From: Watkins, Robert
Sent: Thursday, December 19, 2019 12:17 PM
To: 'howardgw3@aol.com'
Subject: December BAR Action - 430 1st Street North

BAR 19-12-05

430 1st Street North

Extend front entry awning

430 1st Street North

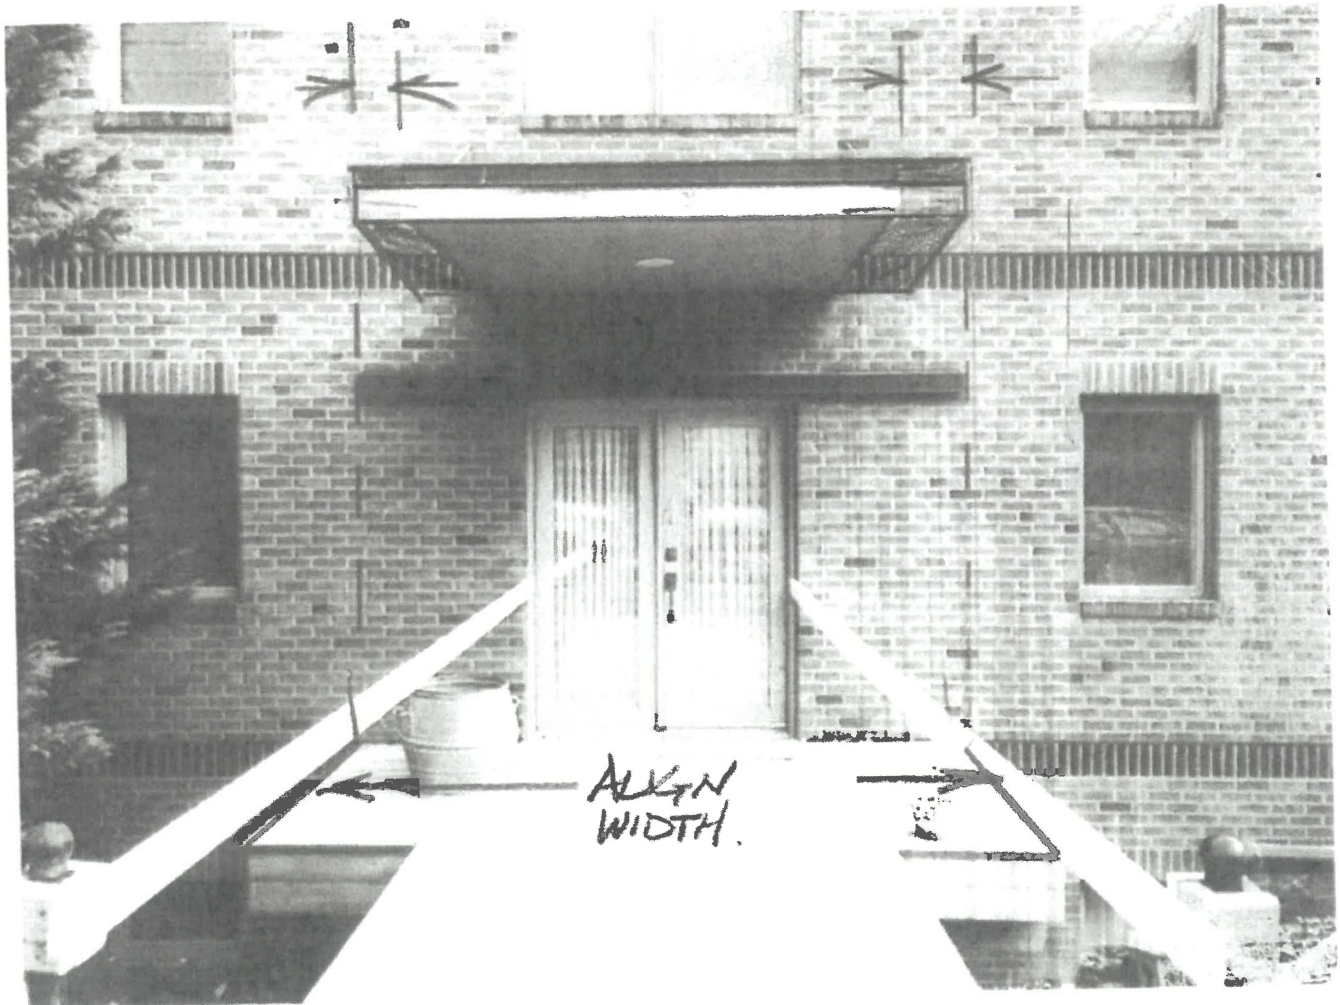
Request for CoA to extend the front entry awning to match the width of the landing below. Materials and design to match the existing awning.

The BAR allowed the entry landing to be widened. The alterations will align the awning with the landing, while maintaining the existing design. (The alteration is consistent with the original design in that the widths of the awning and landing were originally aligned.) Where staff would not support more substantive changes to this building, extending this awning is respectful of the original design and, as a single element, does not represent the initiation of additional, incremental and arguably related alterations.

Balut moved having considered the standards set forth within the City Code, including City Design Guidelines for New Construction and Rehabilitations, I move to find that the proposed alterations to the front entry canopy satisfy the BAR's criteria and are compatible with this property and other properties in the North Downtown ADC District and that the BAR approves the application as submitted. Mohr seconded. Approved (9-0).
